30-039-23650 CANYON LARGO UNIT #308
HILCORP ENERGY COMPANY

HILCORP ENERGY COMPANY
CANYON LARGO UNIT 308
P&A NOI

Attachment to notice of
Intention to Abandon:

Re: Permanent Abandonment
Well: Canyon Largo Unit 308

CANYON LARGO UNIT 308 - PROPOSED WELLBORE SCHEMATIC

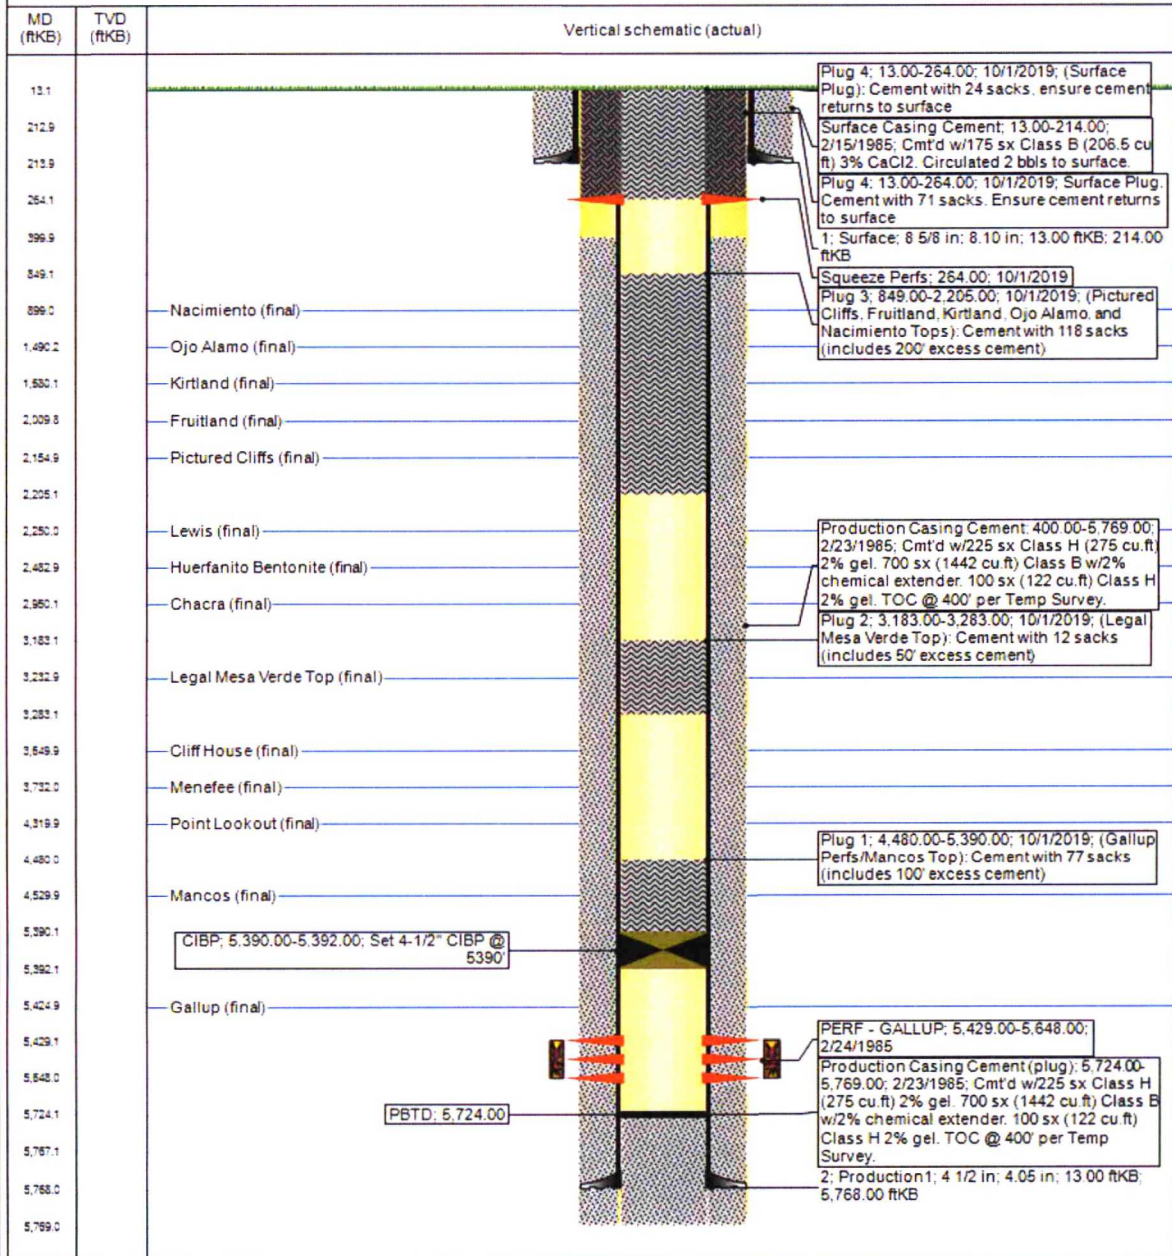
- Notify NMOCD 24hrs prior to beginning operations.
- Add Chacra Plug 2900'-3000'. OCD Chacra top: 2950'

1. Plugging operations authorized are subject to the attached "General Requirements for Permanent Abandonment of Wells on Federal and Indian Lease."
2. Farmington Office is to be notified at least 24 hours before the plugging operations commence (505) 564-7750.
3. Submit electronic copy of the CBL for verification to the following addresses: jkillins@blm.gov and Brandon.Powell@state.nm.us . Based on CBL results inside/outside plugs and volumes will be adjusted accordingly. Please review the General Requirements document to ensure volumes meet required excess inside and outside casing.
4. Add an additional plug (3,600'-3,700') to cover Cliffhouse top at 3,650'.
